SERVICE BULLETIN CHANGE NOTICE

S.B. No. A320-21-1030 REV. 1

TITLE : AIR CONDITIONING - AVIONICS COOLING - IMPROVE EFFICIENCY OF  
WATER DUST STOPPAGE.

REVISION TRANSMITTAL SHEET

Avionics Ventilation System  
Removal of Demister Filter Assembly with its Drain System  
Figure 1, Sheet 1 of 2

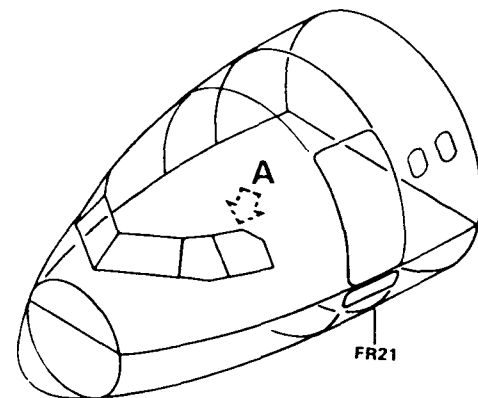
Removal of demister filter assembly (2080HM) with its drain system

(a) Remove (Ref. AMM 21-26-43, P. Block 401) :

1 demister filter assembly (2080HM) Item (13)

NOTE : The cartridge P/N 420A200-2, part of demister filter assembly, can be retained at removal and re-installed upon request from operators.

(c) Remove drain assembly :

2 screws	Item (16) (discard)
2 washers	Item (17) (discard)
2 clamps	Item (18) (discard)
2 supports	Item (19) (discard)
2 clamps	Item (20) (discard)
1 te	Item (21) (discard)
1 hose	Item (22) (discard)
1 hose	Item 23 (retain)
1 hose	Item 24 (retain)
2 clamps	Item 20 (retain)

Avionics Ventilation System  
Installation of Demister Filter Assembly  
Figure 1, Sheet 2

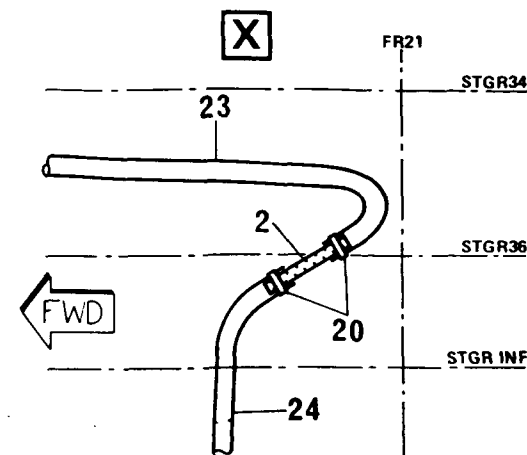
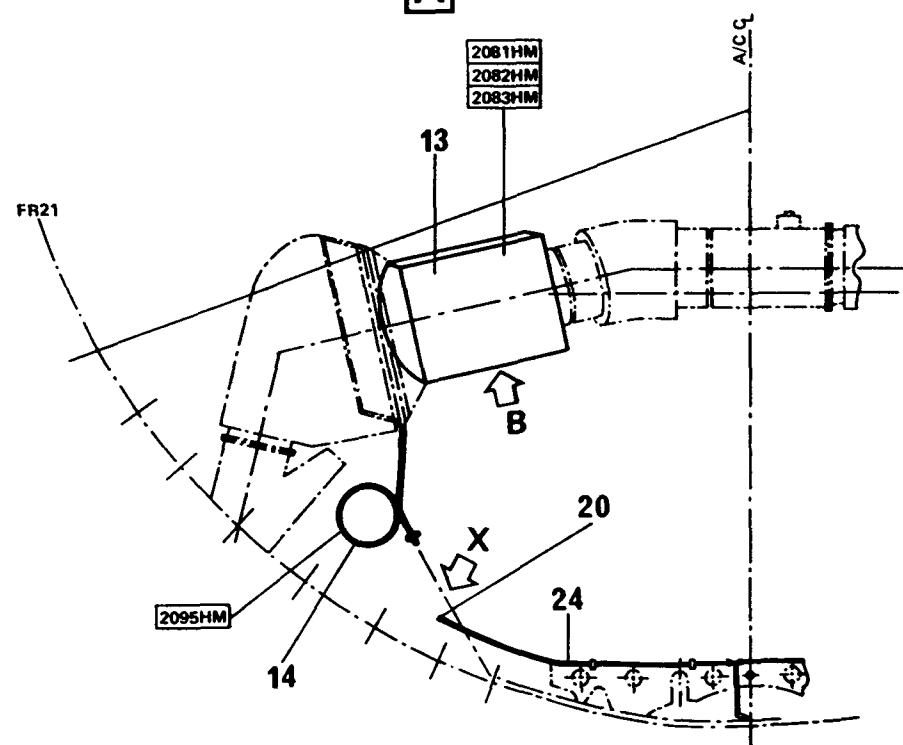
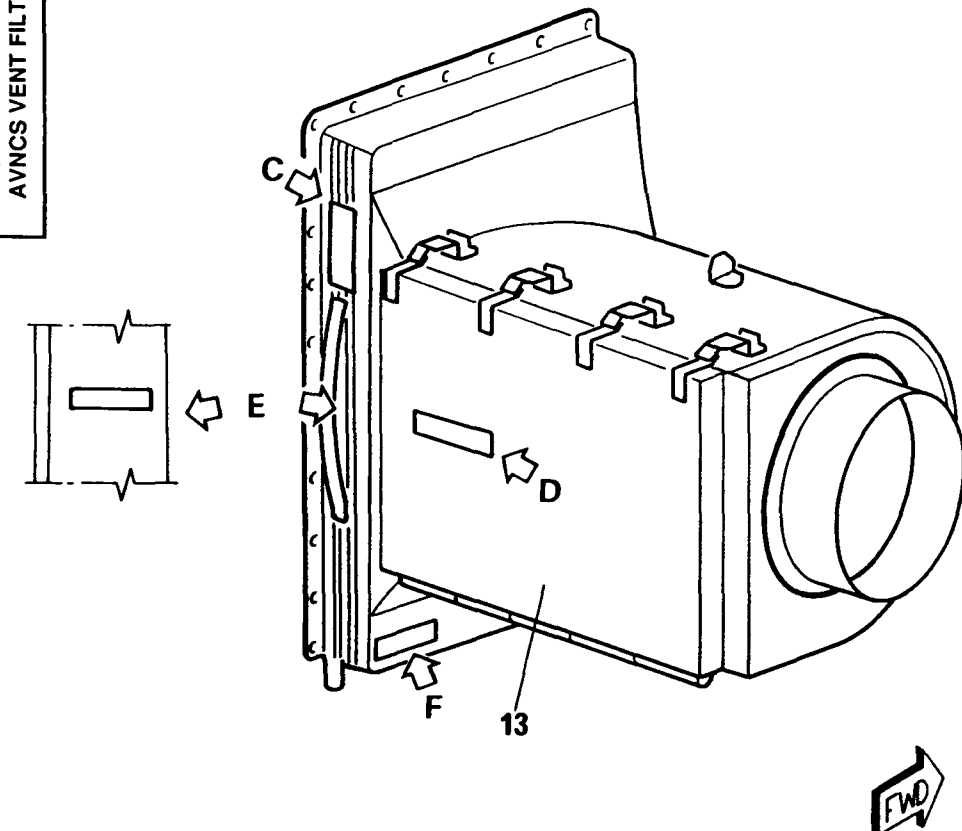
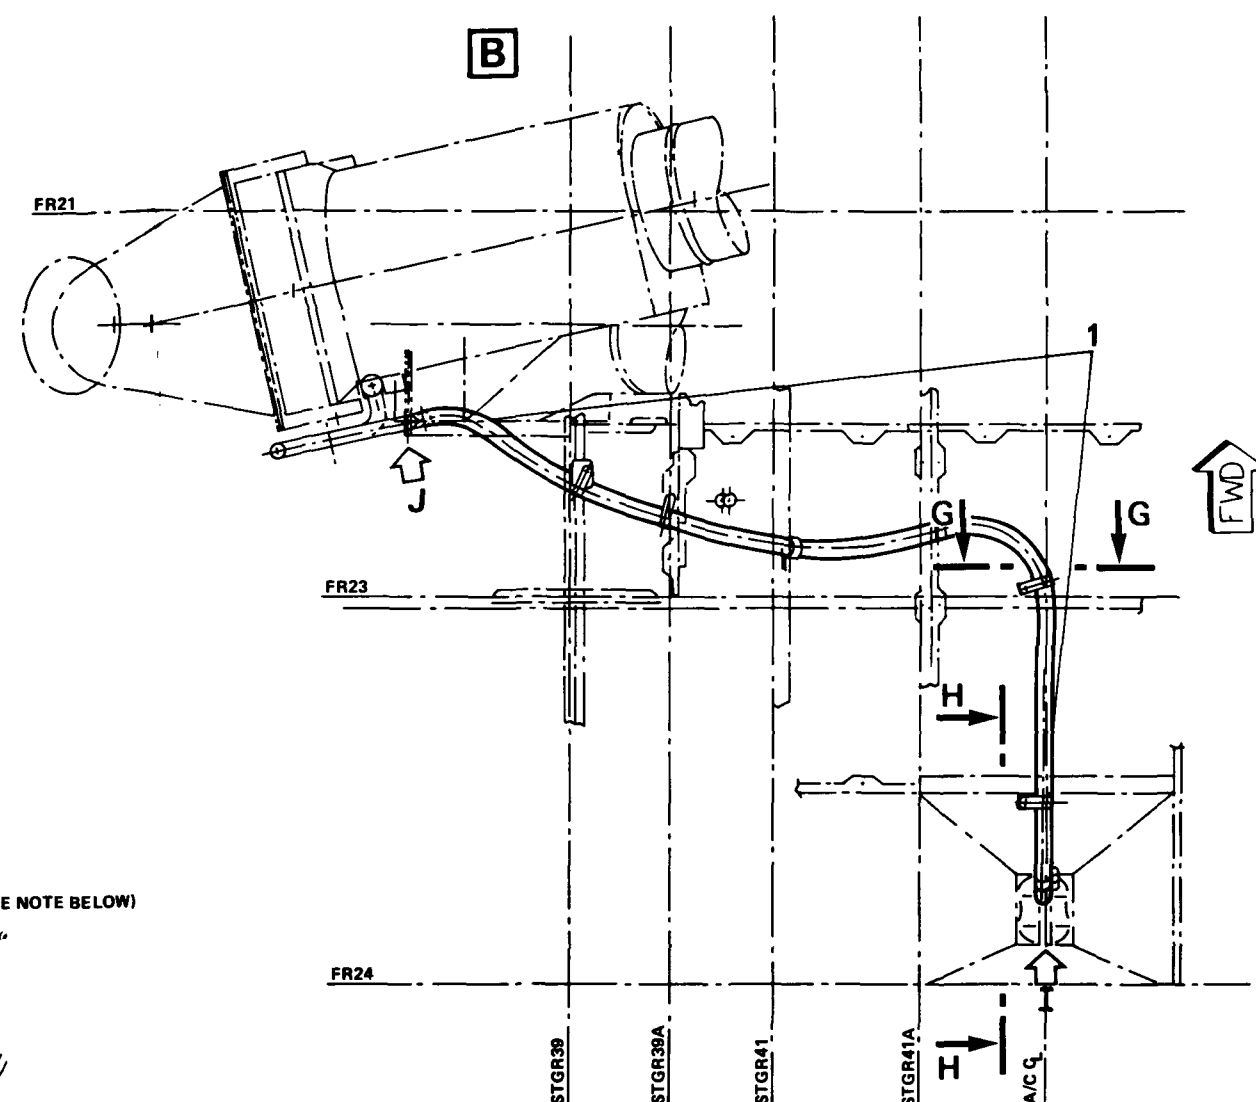
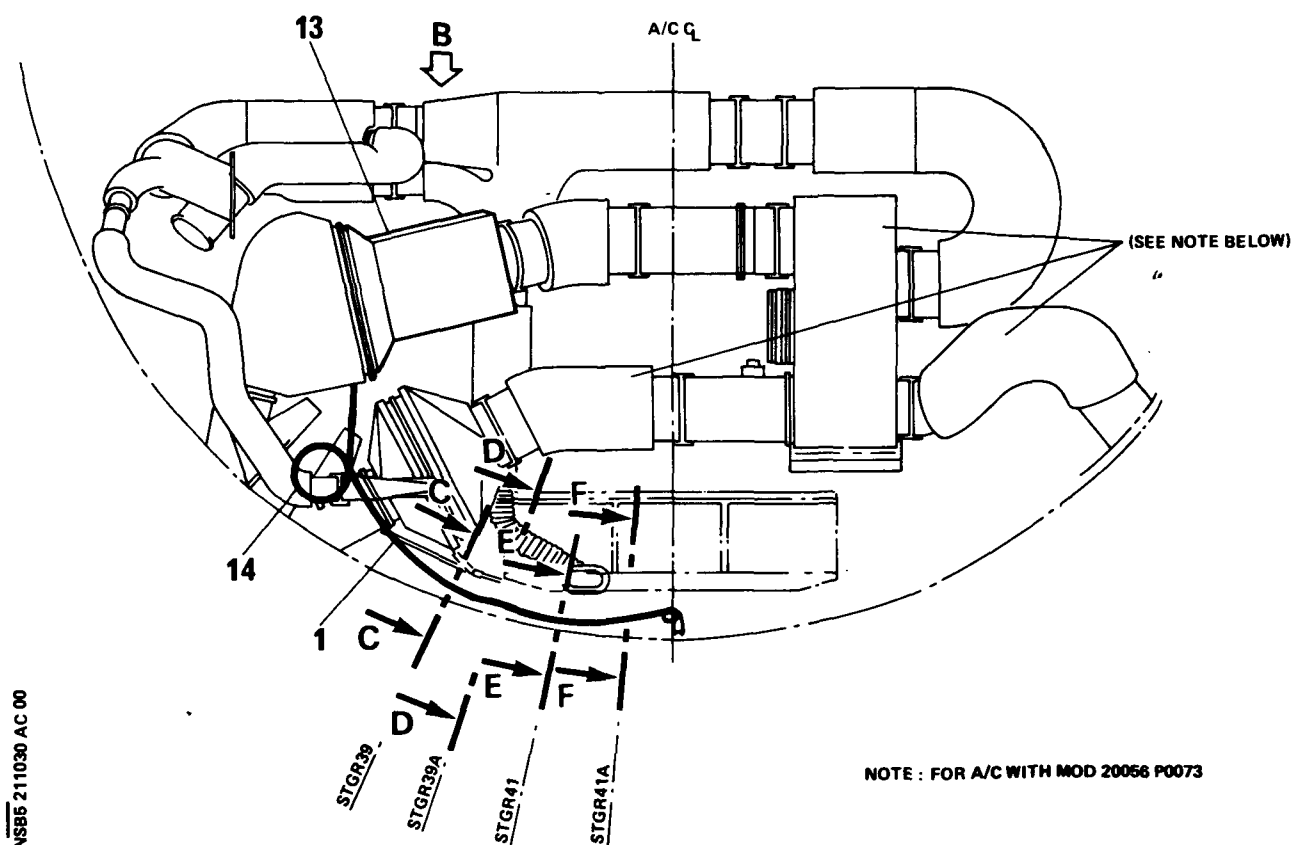
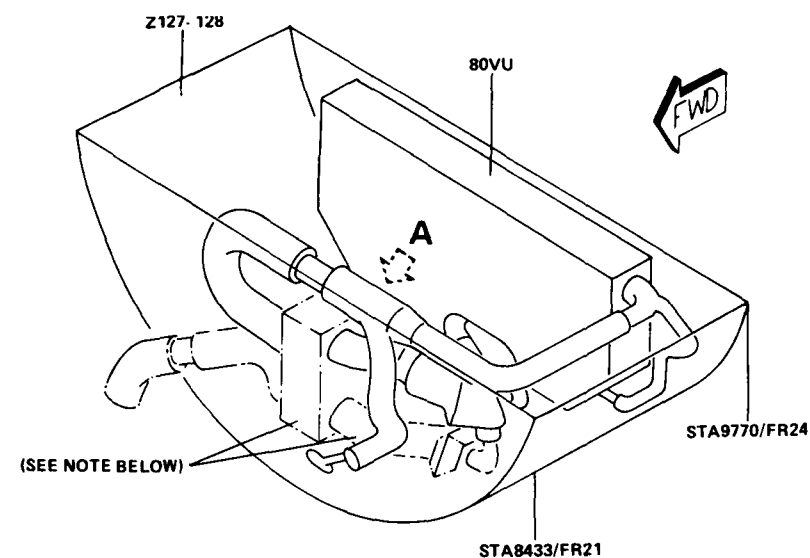
Installation of new demister filter assembly with its drain

(a) On hoses Item 23 and Item 24, install :

1 round tube ASNA30951636 Item 2

(c) Perform protective finish on round tube Item 2 using Mat. No. 13-002, 16-002, 16-006 (Ref. CML).

(d) Install (Ref. AMM 21-26-43, P. Block 401) :

1 demister filter	34800A200-2	Item 13
1 tube assembly	SF0090	Item 14

NOTE : The cartridge P/N 420A200-2 retained at removal can be re-installed instead of the cartridge P/N 420A200-2 delivered with the new demister filter assembly.

1 placard identified 2081HM demister	(View C)
1 placard identified 2082HM cartridge	(View D)
1 placard identified 2083HM housing	(View E)
1 placard identified 2095HM tube assembly	(View F)

Avionics Ventilation System  
Installation of the Drain System on New Demister Filter Assembly  
Figure 2, Sheet 1 of 4

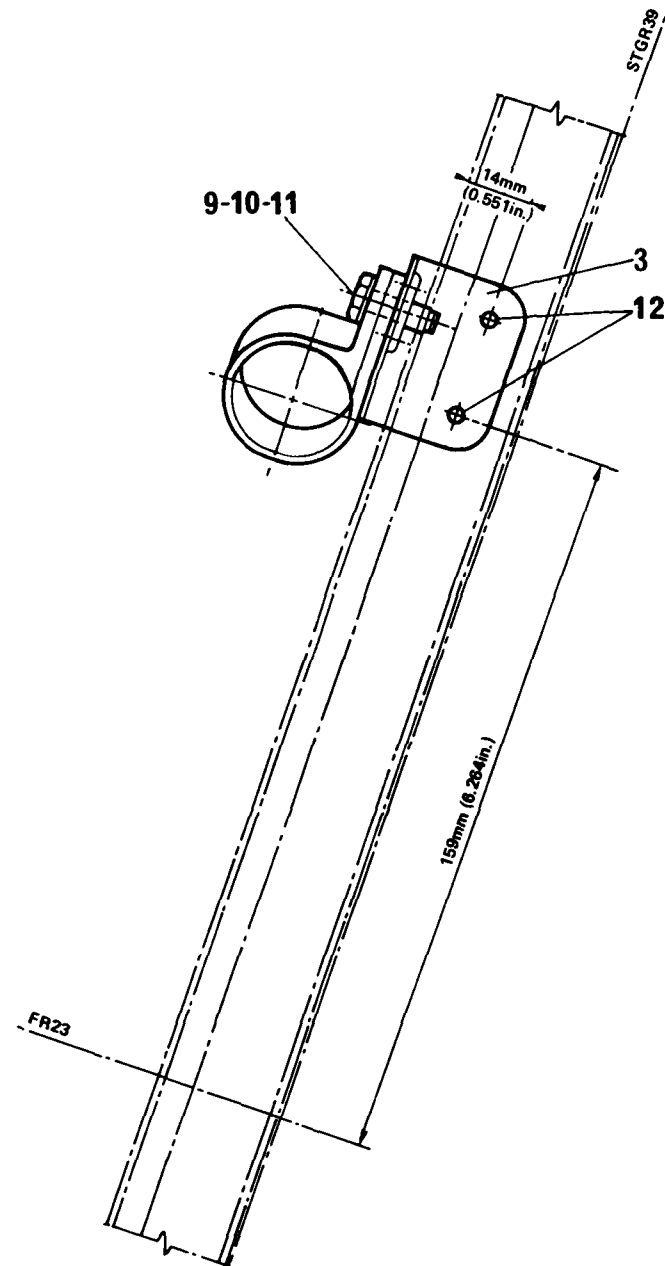
(a) Install brackets with hose between frame 21 to frame 24, left side.

Connect the hose Item 1 with the tube assembly LE BOZEC ET GAUTIER, Item 14.

Refer to Figure 2, Sheet 1 of 4, View J

1 clamp	ASNA0033036	Item 8
---------	-------------	--------

Avionics Ventilation System  
Installation of Brackets on Stringer 39 and on Web of Stringer 39A  
Figure 2, Sheet 2

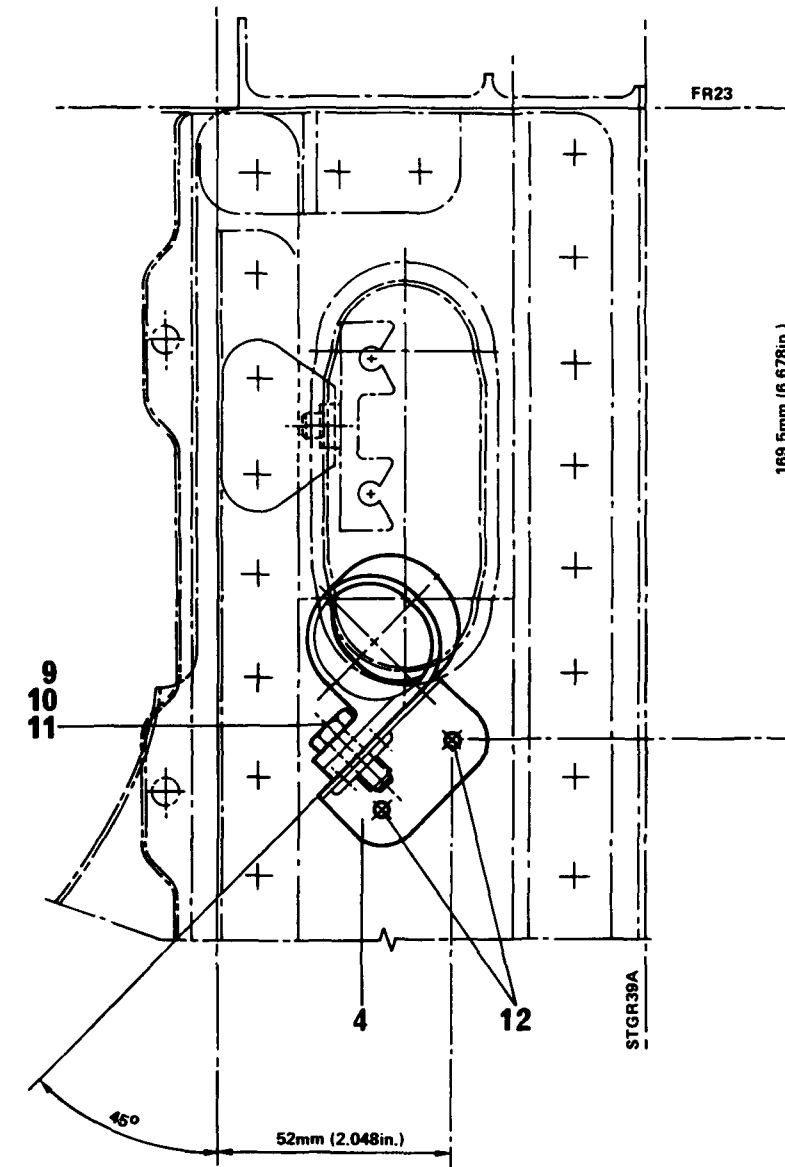
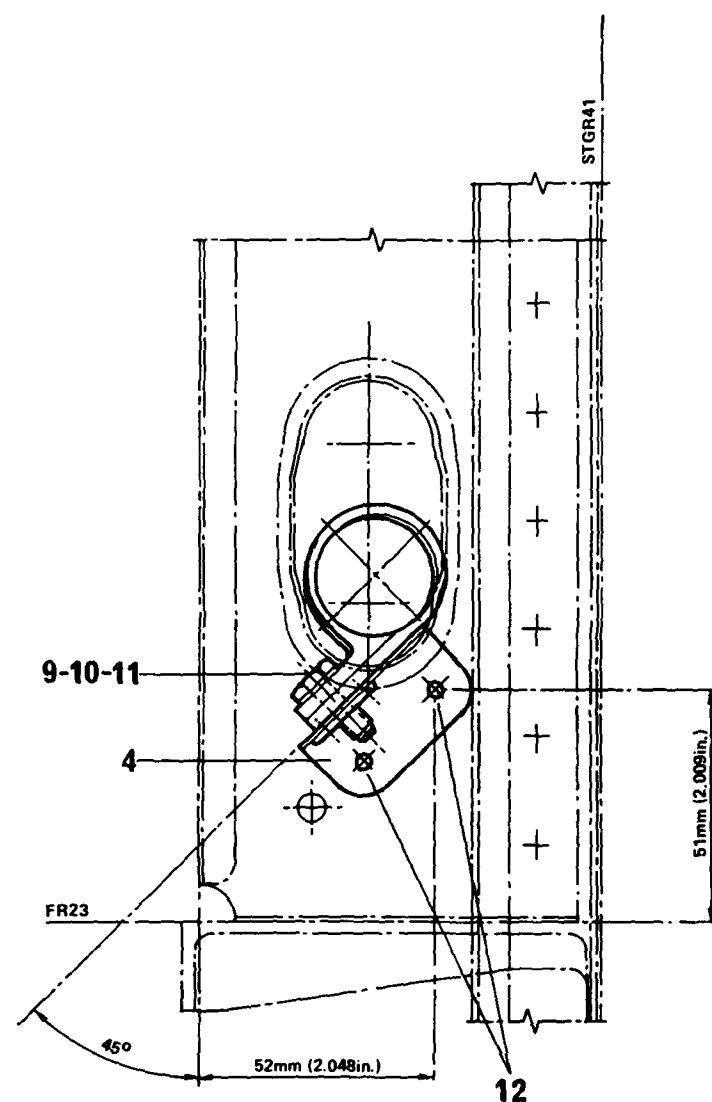
1 On stringer 39, Ref. Fig. 2, Sheets 1 of 4 and 2 (Section C.C)

Respecting the required dimensions, position, match drill holes between 3.2 mm (0.126 in.) min. and 3.3 mm (0.130 in.) max. in accordance with :

**SERVICE BULLETIN****2 On web of stringer 39A, Ref. Fig. 2, Sheets 1 of 4 and 2  
(Section D.D)**

Respecting the required dimensions, position, match drill  
holes between 3.2 mm (0.126 in.) min. and 3.3 mm (0.130 in.)  
max. in accordance with :

Avionics Ventilation System  
Installation of Brackets on Web between Stringer 41 to 41A  
Figure 2, Sheet 3

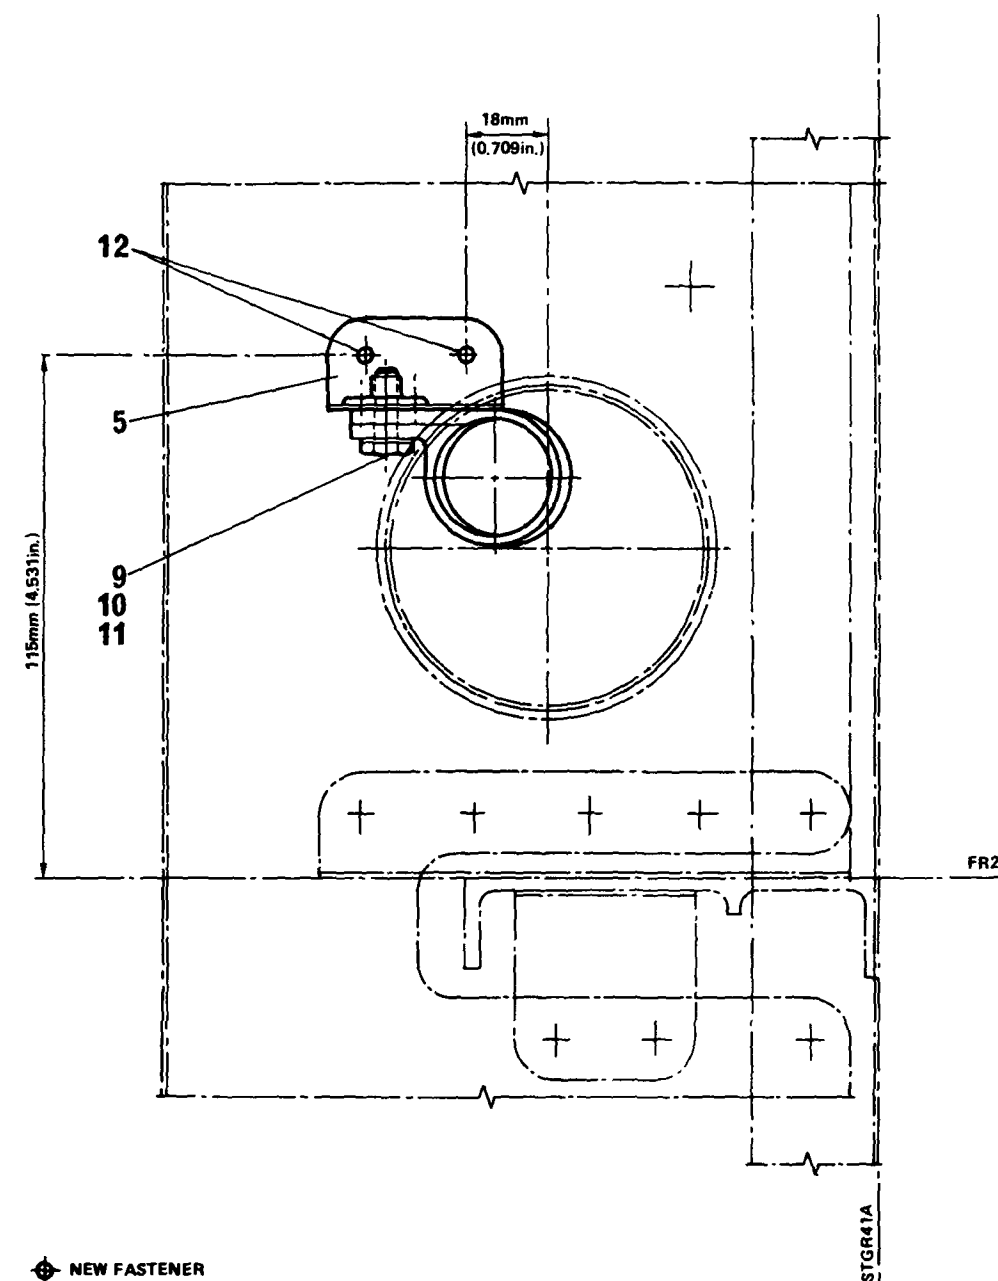
**3 On web of stringer 41, Ref. Fig. 2, Sheets 1 of 4 and 3  
(Section E.E)**

Respecting the required dimensions, position, match drill  
holes between 3.2 mm (0.126 in.) min. and 3.3 mm (0.130 in.)  
max. in accordance with :

**4 On web of stringer 41A, Ref. Fig. 2, Sheets 1 of 4 and 3  
(Section F.F)**

Respecting the required dimensions, position, match drill  
holes between 3.2 mm (0.126 in.) min. and 3.3 mm (0.130 in.)  
max. in accordance with :
